Access Compliance Report

Public Rights-of-Way

(Curb Ramps)

Intersection ID: 10257	Main Street: E_36TH_ST	Cross Street: N_MCDOWELL_ST	Location: W
ADA ID: A6E61511B654	Ramp Type: PerpDiag	Initial Pass/Fail: Pass	Overall Compliance: No
		Severity Score: 25

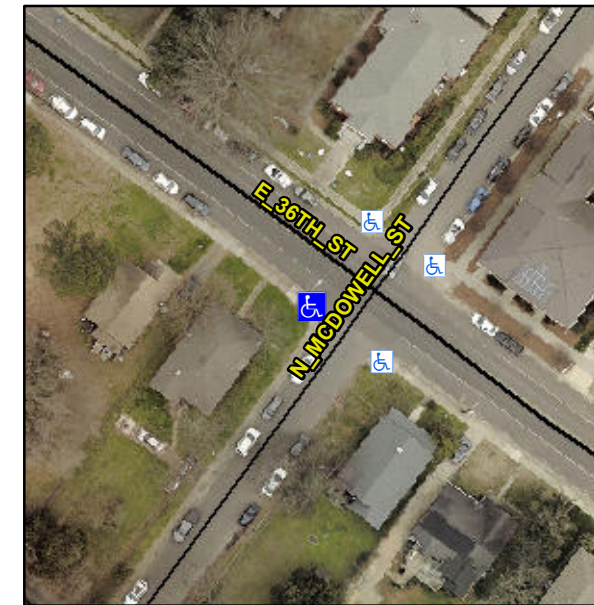
Not Found, R304.2.1, R304.2.2-Perp, R304.3.2-Para, R304.5.3, R305.2, R302.7.2

Remove & Replace Curb Ramp With Two New Directional Ramps or Equivalent.
